REGULATION NO.125 (Forward field of vision of drivers)

Proposal to review the requirements for forward field of vision in Regulation No.125

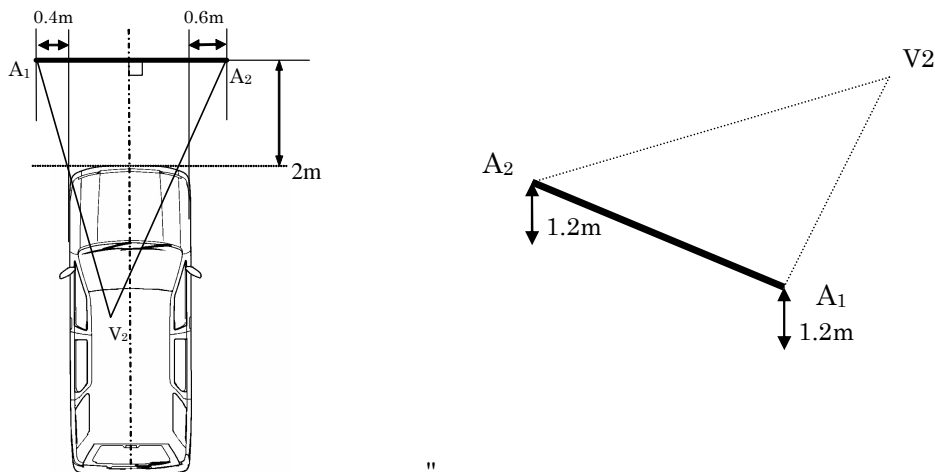
Other than the obstructions created by the A pillars, outside radio aerials, mirrors and windscreen wipers, there should be no obstruction in a plane passing through the three points A_1 , A_2 , and V_2 , where A_1 is a point 0.4 m outside of the outermost edge of the vehicle on the driver's side on a line parallel to the horizontal plane and perpendicular to the central axis of the vehicle and situated 2 m in front of the foremost edge of the vehicle and 1.2 m above ground, and A_2 is a point 0.6 m outside of the outermost edge on the other side of the vehicle on the said line.

(2) For vehicles with high ground clearances, V2 is also high, which means it is not always possible for the driver to perceive small vehicles in front, such as motorcycles, that come below the plane 4 degrees below V2. This new provision will enable the forward field of vision to be ensured even for high-ground-clearance vehicles (see figures below).
